UNITED STATES PATENT AND TRADEMARK OFFICE

10/629,232

Office Action Summary

DETAILED ACTION

FIG. 1

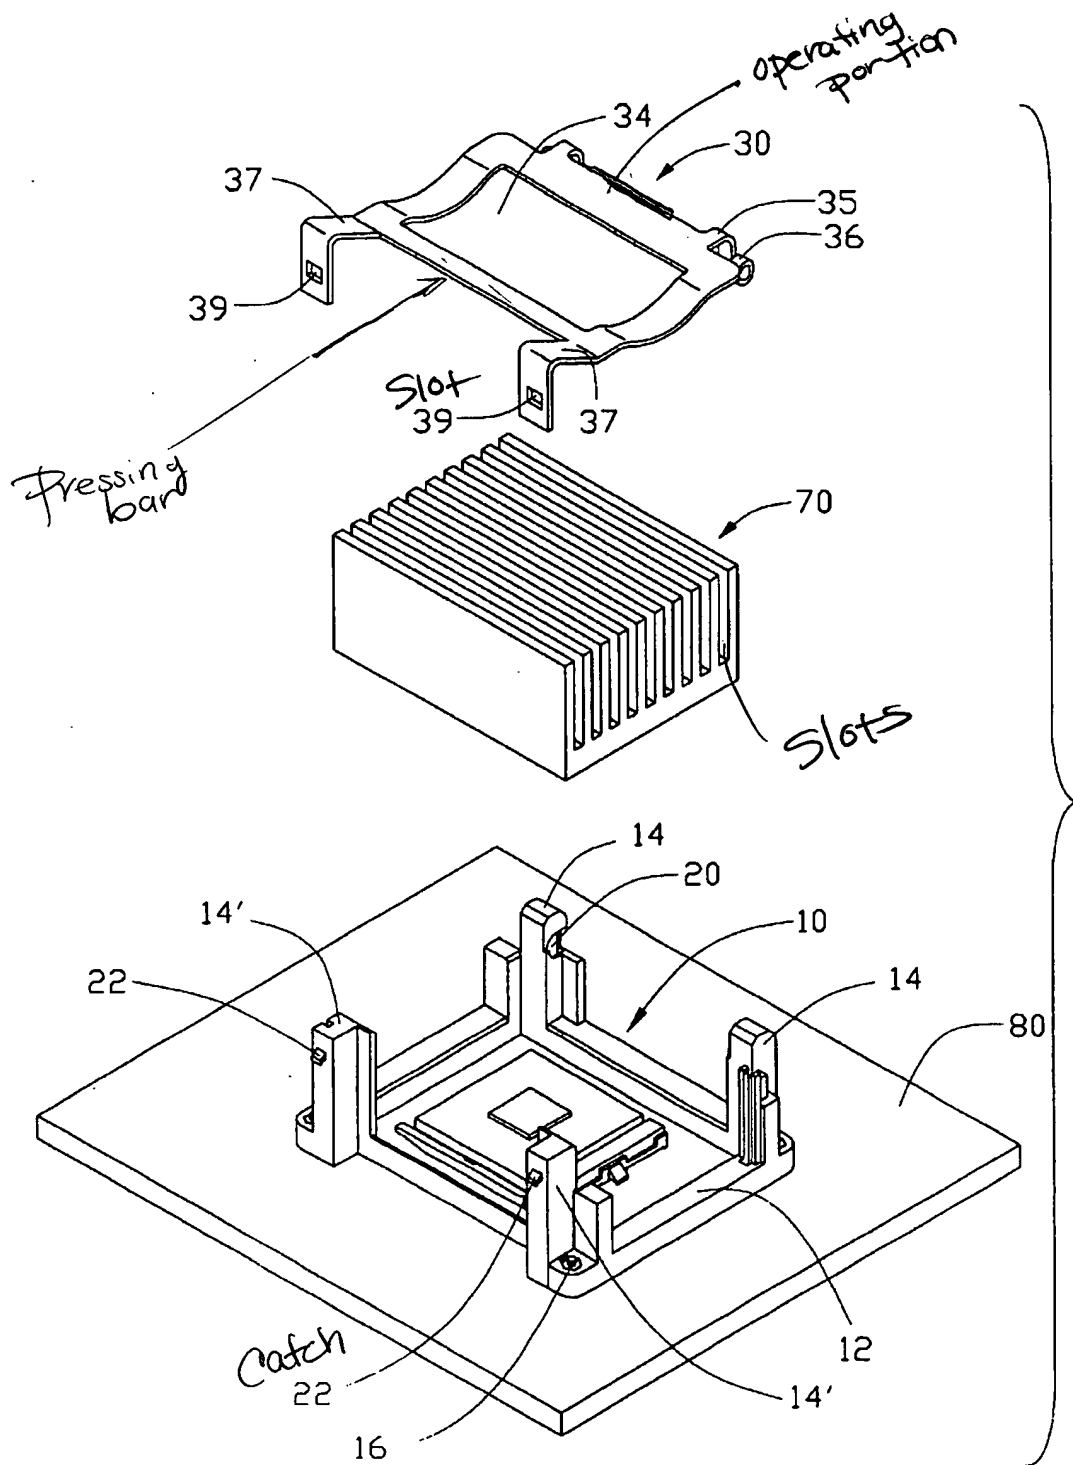
McHugh et al. teaches an operating portion (see, notation on attached fig. 1 of McHugh et al.) of a clip (30), which defines a slot (see, notation on attached fig. 1 of McHugh et al.) and an additional operating portion (see, notation on attached fig. 8 of McHugh et al.), of clip (see, notation attached fig. 8 of McHugh et al.), which defines a slot (see, notation on attached fig. 8 of McHugh et al.), for securing a heat sink to a CPU on a circuit board (see, Abstract of McHugh et al.).

McHugh et al. teaches pressing bars (see, notation on attached fig. 1 of McHugh et al.) extending through corresponding slots (see, notation on attached fig. 1 of McHugh et al.) of a heat sink (70) and an additional pressing bar (see, notation on attached fig. 8 of McHugh et al.) corresponding through slots (see, notation on attached fig. 8 of McHugh et al.) of a heat sink (9) of a prior art, for securing a heat sink to a CPU on a circuit board (see, Abstract of McHugh et al.).

FIG. 8
(PRIOR ART)

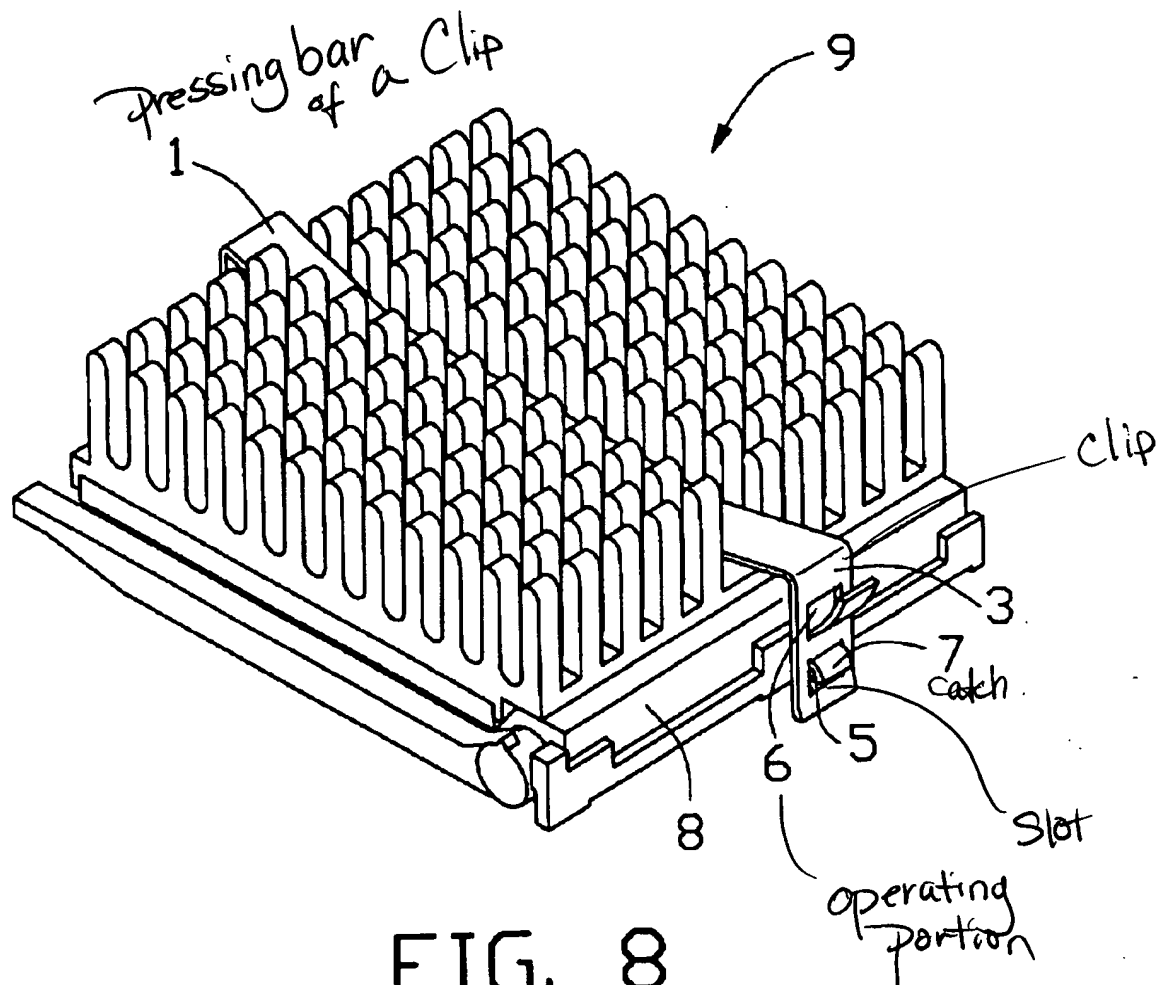
It would have been obvious to one having ordinary skill in the art at the time the invention was made to utilize the pressing bars of McHugh et al., in the invention of Katsui, in order to provide an easier means of securing a heat sink to a CPU on a circuit board. In particular, screws (92) and cover portion (84) of Katsui will be replaced, with a clip (see, notation on attached fig. 8 of McHugh et al.), secured by a catch (see, notation on attached fig. 8 of McHugh et al.) through a slot (see, notation on attached fig. 8 of McHugh et al.). A screw driver will be eliminated, and

FIG. 1

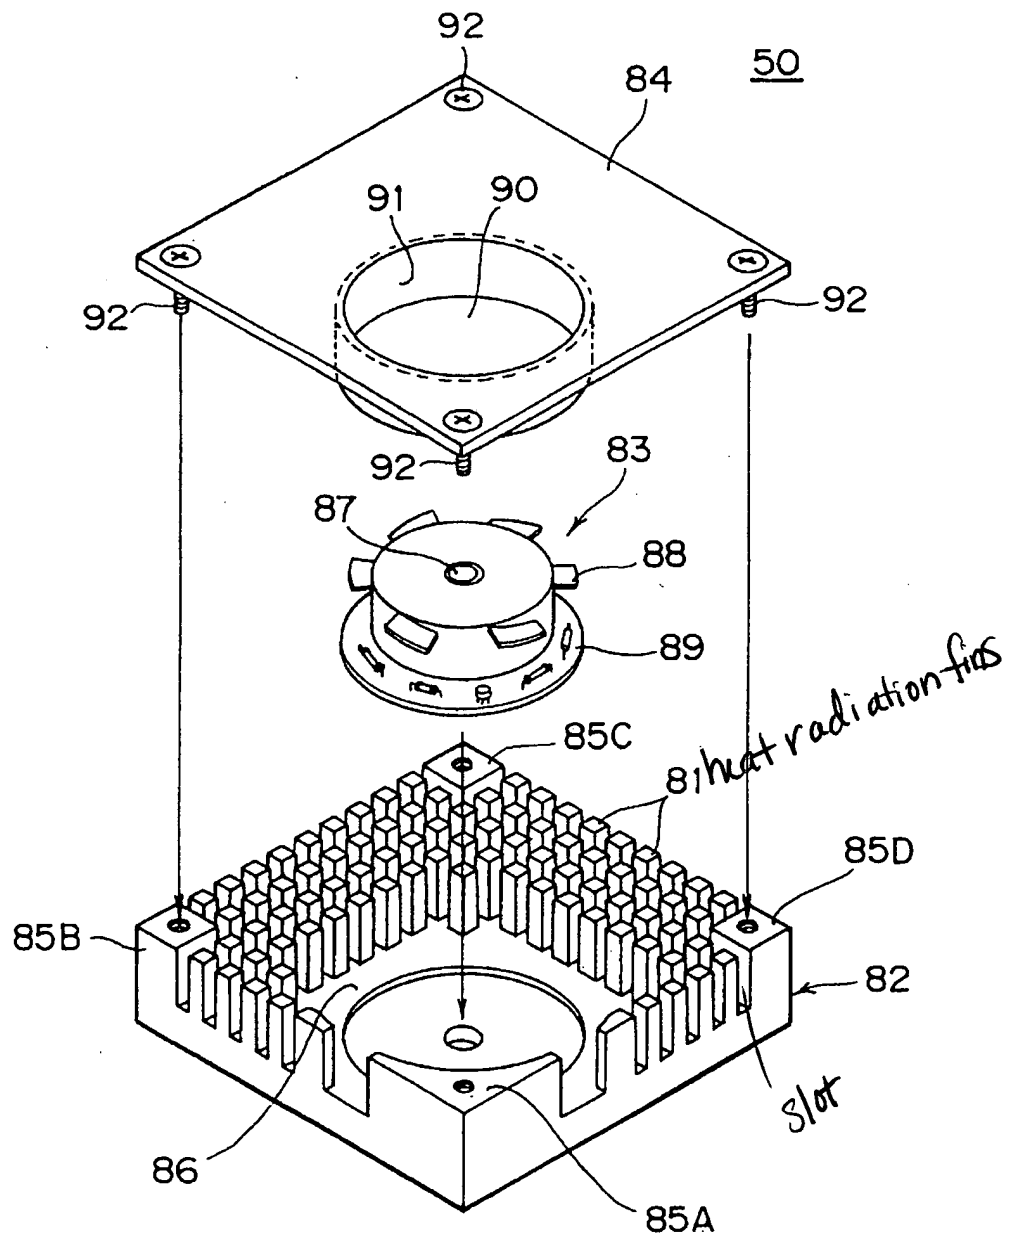
With respect to claims 1 & 12 respectfully, Katsui teaches (see, fig. 1) a printed circuit board (10) having an electronic package (20); a retention module (30) surrounding the electronic package (20), the retention module (30) being integrally formed and defining two positioning holes (see, notation on attached fig. 1 of Katsui) at symmetrically opposite sides of a center thereof two screws (see, notation on attached fig. 1 of Katsui) threadedly screwed in holes (see,

With respect to claim 2, in regards to all the limitations of claim 1 above, Katsui teaches (see, fig. 1) a pair of locating holes (see, notation on attached fig. 1 of Katsui) corresponding to the positioning holes (see, notation on attached fig. 1 of Katsui) of the retention module (30), and the screws (40), but is silent as to the pins (40) being welded into the locating holes (see, notation on attached fig. 1 of Katsui).

With respect to claim 11, Katsui teaches (see, fig. 1 of Katsui) a retention module (30B) substantially rectangular, and the two positioning holes (see, notation on attached fig. 1 located through structure of element (30B)) defined in diagonally opposite corners of the retention module (30B) (see, column 4, lines 44-53 of Katsui).

With respect to claim 13, Katsui teaches (see, fig. 1 of Katsui) pins (40) disposed at symmetrically opposite sides of a center of the retention module (30).

With respect to claim 15, in regards to all the limitations of claim 12 above, Katsui teaches (see, fig. 1 of Katsui) positioning holes (seem notation on attached fig. 1 of Katsui) defined in the retention module (30) and screws (40), but is silent as to first ends of the pins being welded to the printed circuit board (10).

With respect to claim 16, Katsui teaches a printed circuit board (10) having an electronic package (20) located thereon and a plurality of through holes (see, notation on attached fig. 1 of Katsui) therein, a retention module (30) surrounding an electronic package (20), pressing portion (62C) of a clip (62), a heat sink (50) and pins (40) in a retention module (30) with four corners and slots (see, notation on attached fig. 2 of Katsui) of a heat sink (50).

FIG. 4B

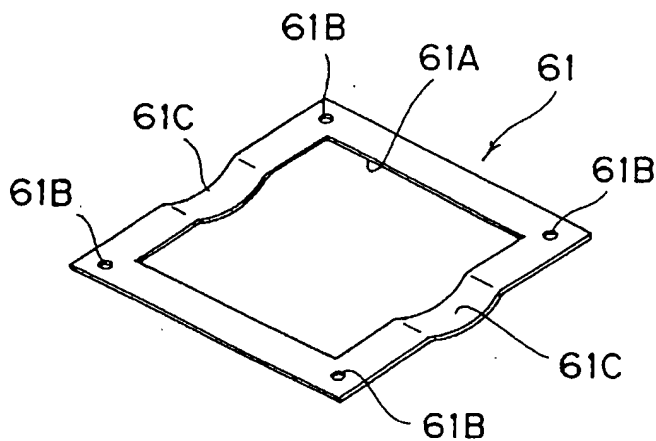
With respect to claim 4, Katsui teaches (Fig. 3,4B) a clip (62) that comprises a pressing portion (62C) to press a heat sink (50) against the electronic package (21), and a pair of clamping portions (62B) engaging with the retention module (31B, 31') (see, column 7, lines 37-50 of Katsui).

With respect to claim 6, in regards to all the limitations of claims 1,4 & 5 above, Katsui teaches (Fig. 4B) a clip (62), the clamping portions (62B) extend from respective opposite sides of the pressing portion (62C) toward the printed circuit board (11), and the clamping portions (62B) form distal hooks engagingly clasping the retention module (31') (see, column 7, lines 37-50 of Katsui).

With respect to claim 7, Katsui teaches (Fig. 4B) a pair of catches (31D) integrally formed outwardly from the retention module (31') at diagonally opposite corners thereof respectively,

With respect to claim 9, Katsui teaches (Fig. 4B) a pair of symmetrical catches (31D) integrally formed outwardly from opposite sides of the retention module (31'), the catches (31D) engaging with the clamping portions (62B) of the clip (62) (see, column 7, lines 37-44 of Katsui).
